ADDENDUM #1

SANTA FE COUNTY
IFB# 2017-0165-PW/KE
HVAC CONSTRUCTION/INSTALLATION
FOR PUBLIC WORKS BUILDING

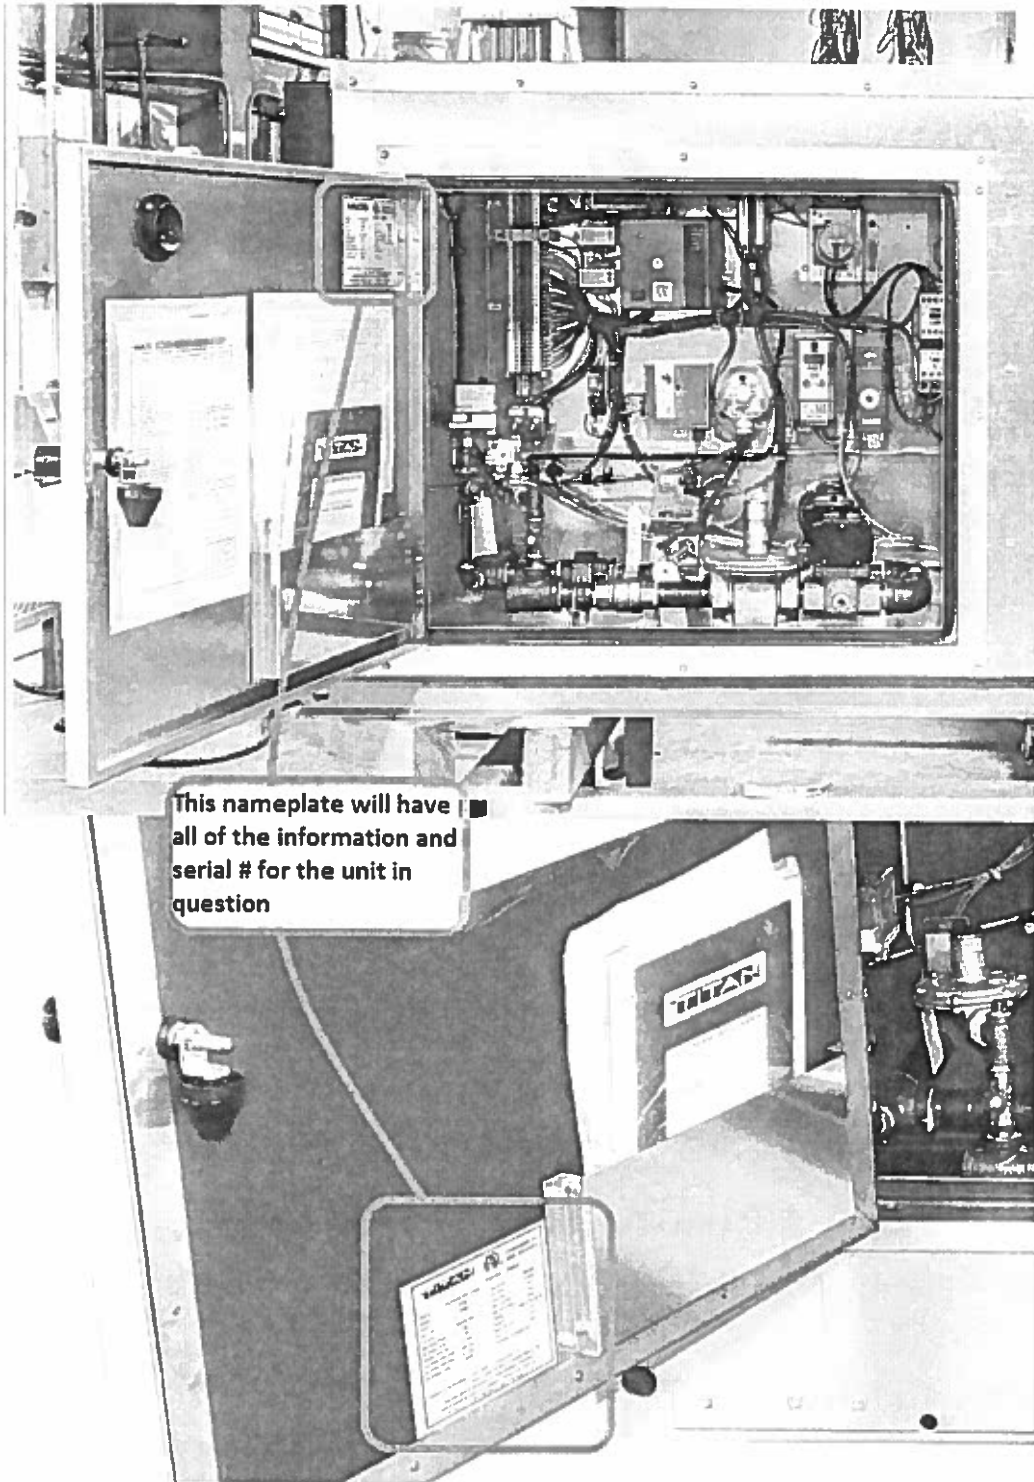
Question 12

Titan has requested the serial numbers of RTU 12,13,18,19 and 20 that require refurbishment. This will help them identify the units in question. Provide the requested serial numbers or other model, tag information to accurately identify the units.

(See below illustration)

Answer 12

RTU-12 Model TAH-2.6-109 FC HW EVARHRD S/N 11431

RTU-13 Titan TAH-2.6-109 FC HW EV ARHRD S/N 11432

RTU-18 Titan TAH-4.7-112 FC HW EV ARHRD S/N 11439

RTU-19 Titan TAH- S/N 11422-40
RTU-20 Titan TAH-6.7-112 FC HW EV ARHRH S/N 11440
